SYDNEY EASTERN CITY PLANNING PANEL

COUNCIL ASSESSMENT REPORT – MODIFICATION APPLICATION

PANEL REFERENCE & DA NUMBER	PPSSEC-204 – DA/20/2021/A
PROPOSAL	S4.56 Modification Application of approved development to amend the development consent granted by the NSW Land and Environment Court, where the development will remain substantially the same as the development that was originally approved. The modification to the approved development is to allow for the provision of a lift overrun, fire stairs, balustrades, accessible toilet, and mechanical plant to the rooftop and minor change to floor levels of the 9-storey student housing building.
ADDRESS	177-197 Anzac Parade, Kensington 2033 The development site comprises six lots as follows: (3,541m ²). <ul style="list-style-type: none"> • 177 Anzac Parade (SP 15366) • 179-181 Anzac Parade (Lot 10 Section 7 DP 4761) • 183-185 Anzac Parade (Lot 11 Section 7 DP 4761) • 187 Anzac Parade (Lot A DP 410791) • 189 Anzac Parade (Lot B DP 410791) • 191-197 Anzac Parade (SP 19239)

① Perspective View From Anzac Parade - Approved

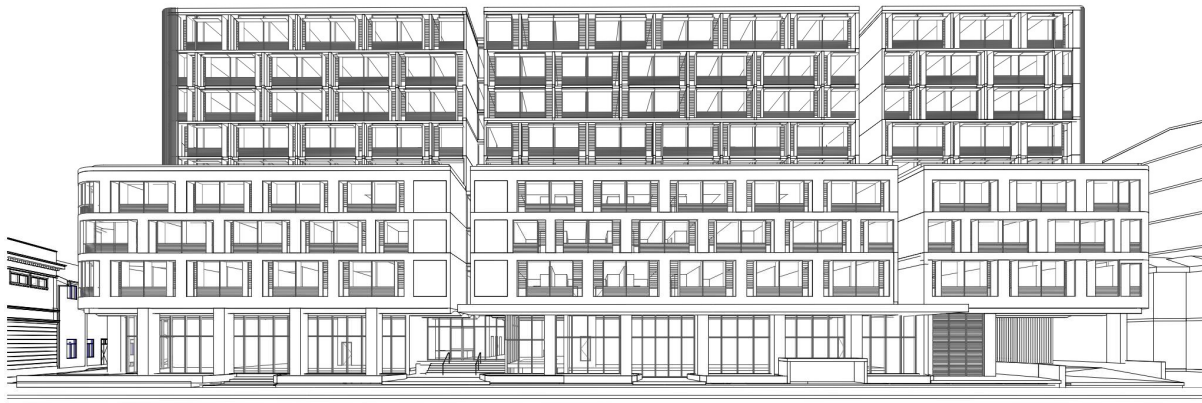
Front elevation along Anzac Parade

Increasing the front setback along Anzac Parade frontage from approved nil setbacks to 2.2m for balustrades, and study nook screens such that landscaping is now included between the proposed balustrades which have a non-compliant height which exceeds the 31m maximum HOB development standard and the compliant parapet height.

The inclusion of landscaping between the structures and parapet along Anzac Parade is considered to satisfy the design excellence and HOB objectives in the LEP.

Perspectives from Roma Avenue. Left 3D images show the approved scheme and at right the proposed scheme with the red lines showing the small parts of the 2.1m high screens that can

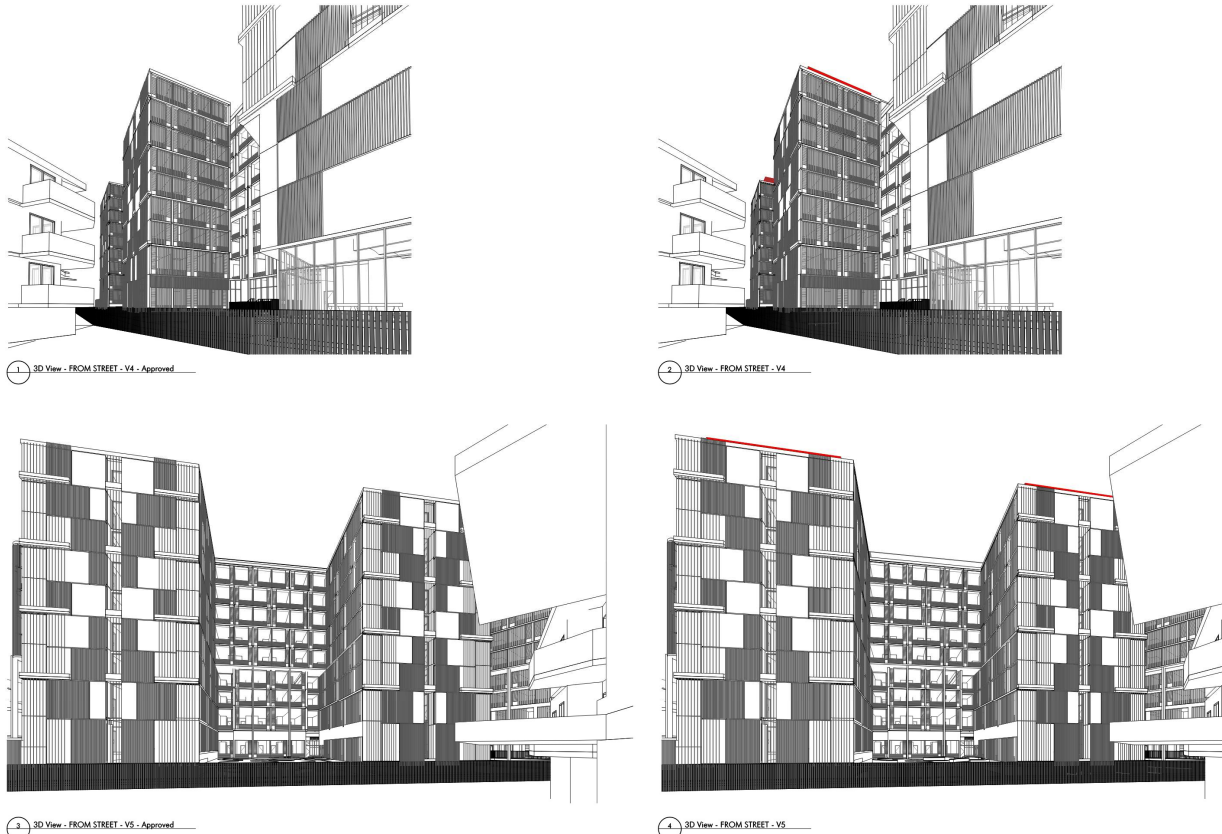
Screening mechanical plant at the rear

The applicant has amended their application by reducing the screen heights by 600mm from 2.1m down to 1.5m resulting in compliant heights for the screens at the northern most wing and also increased setbacks from the southern end of the parapet. The only element that continues to extend above the 31m maximum HOB development standard is the central screen which is 31.73m and 730mm above the HOB development standard.

The 3-D images below, show the superseded the Rev C plans shows that the 2.1m high screens without the setbacks, will be visible from the Roma Avenue perspectives. The perspectives for the revision D plans (further below) show that the reduced height as well as increased setbacks will ensure no view of the screens from these perspectives.

Perspectives reflect the Revision D plans subject of assessment show that no part of the mechanical screens will be viewable.

Approved (top row 12.30pm to 1.30pmn) and proposed shadow impact on No. 24 Roma Avenue

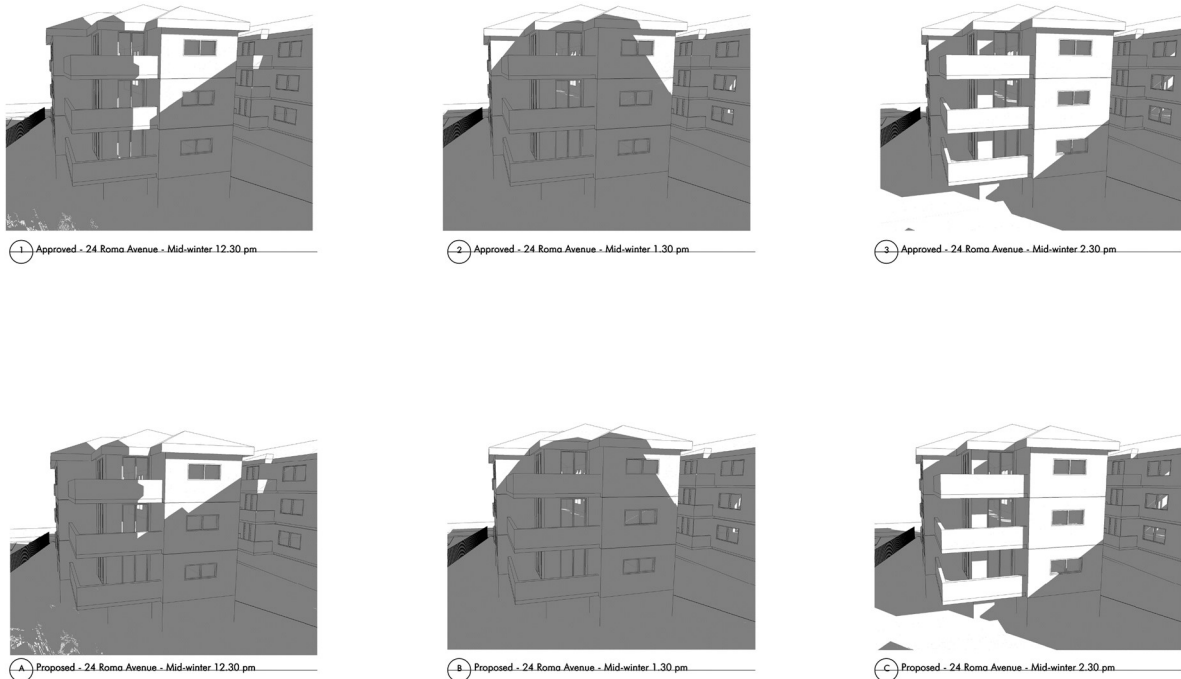
- The majority of it falls well beyond the adjoining properties, and where the overshadowing is occurring over the neighbouring properties it is mostly cast over the roof of these buildings.

- Solar access will be retained to the majority of the neighbouring buildings roofs.
- There will be some additional overshadowing to No. 24 Roma Avenue and 113 Doncaster Avenue, however this is only minor increase, and it is considered that the reduction in screen height and increased setback would likely reduce this overshadowing.

The applicant submitted elevation shadow diagrams received by Council 5.12.22 showing that there will be no difference in shadow impact between the approved scheme and that proposed as part of this application as amended.

Amended roof terrace plan DA022 Rev D dated 5.12.22.

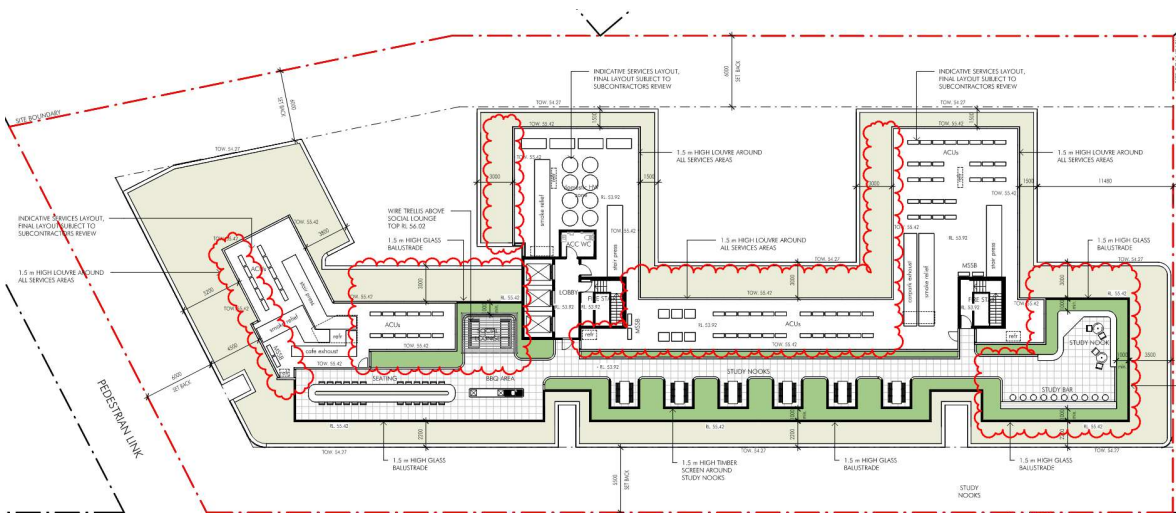
- *DEAP comment: Detail of edge condition balustrade and perimeter planters near habitable space, to make the planting visually accessible and contributing to the nature of the space, instead of segregated from it. Detail of balustrade, including materiality, and impact (or not) on views from the roof terrace. Glazed balustrades are questionable in locations such as these, given the challenges of accessing them to clean them regularly, which they will require.*

Amended landscape plan showing increased setback of screens noting screens to study nooks (blue lines) have subsequently been lowered and roof plant at the right of the image has been relocated further south and replaced with study area shown immediately below in the Rev D roof plan.

Applicant response: Refer to Landscape Rooftop Plan and Landscape Rooftop Sections for Balustrade locations and Detail Sheet 502-503.

Assessment officer comment: The landscape roof plan and sections (arcadia package Issue 22), relates to a superseded scheme, different to the Rev C and Rev D roof plans (shown above). Council's landscape officer has reviewed the landscape and amended scheme and recommends that the landscape plans be amended to reflect the amended architectural plans. A further condition is included to require landscape plans to include as much landscaping as possible within the front setback along Anzac Parade.
